Staff Report & Recommendation

Design Review Board

SUBJECT: DRB24-1014
4-6 Star Island

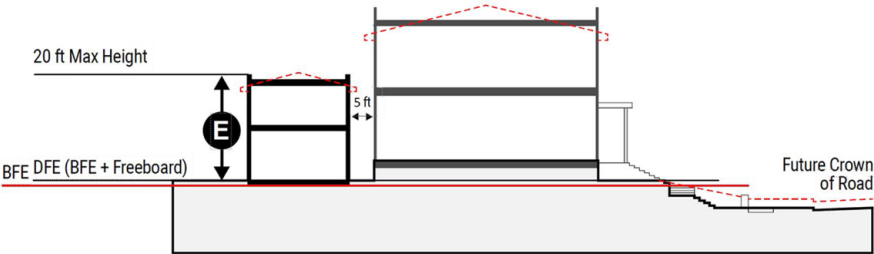
The Applicant is requesting a five (5) foot height variance for the one-story cabana accessory structure at the rear yard. The cabana is proposed at a height of 17 feet and 9" which exceeds the maximum height of 12' for a one-story accessory structure. It is important to note that for accessory structures, the height is measured from base flood elevation plus one foot of freeboard. When facing a waterway, the minimum setback for a one-story accessory structure is one half of the required rear setback. In contrast, the minimum required setback for a two-story accessory structure along an interior side yard is 10 feet or the required side yard setback. The rear setback for a two-story accessory structure consists of one half of the required rear setback or 15', whichever is greater.

Staff is supportive of the height variance due to the proposed accessory structure complying with the greater setback requirements of a two-story structure. The lush landscaping along the side yard is set partially on a lower terrace than the pool and therefore minimizing the height in relation to the pool. Consequently, the granting of the variance requested will not confer on the applicant any special privilege that is denied by these land development regulations to other lands, buildings, or structures in the same zoning district. While staff has no objection to the granting of the proposed variance, pursuant to Article I, Section 2 of the Related Special Acts, the maximum height variance that can be approved by the board is three (3) feet. As such, staff recommends that the variance be approved, not to exceed 3 feet.

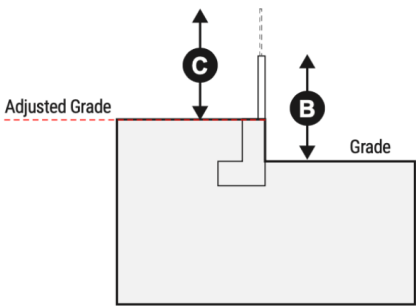
Variance #8 is related to a fence along the interior south side yard proposed at 12'-6" from the grade elevation of 5'-6" NGVD where the maximum height allowed is 7'-0". In the past, the height of the fence, measured from grade elevation has been associated with variances when the grade of the property is very low. The Code has been modified to allow the interior side fence to be measured from future adjusted grade, which is a higher elevation than grade, provided that the portion of such fences, walls or gates above 4 feet in height consists of open pickets with a minimum spacing of 3 inches. Additionally, landscaping can be utilized to screen the property more fully. Based on this analysis, staff recommends denial of variance #8. However, if the Board decides to approve the variance, staff recommends limiting the variance to a height of 10' from grade elevation so that it is consistent with Article I, Section 2 of the Related Special Acts of the City Charter, which states that height variances of greater than 3 feet cannot be granted.
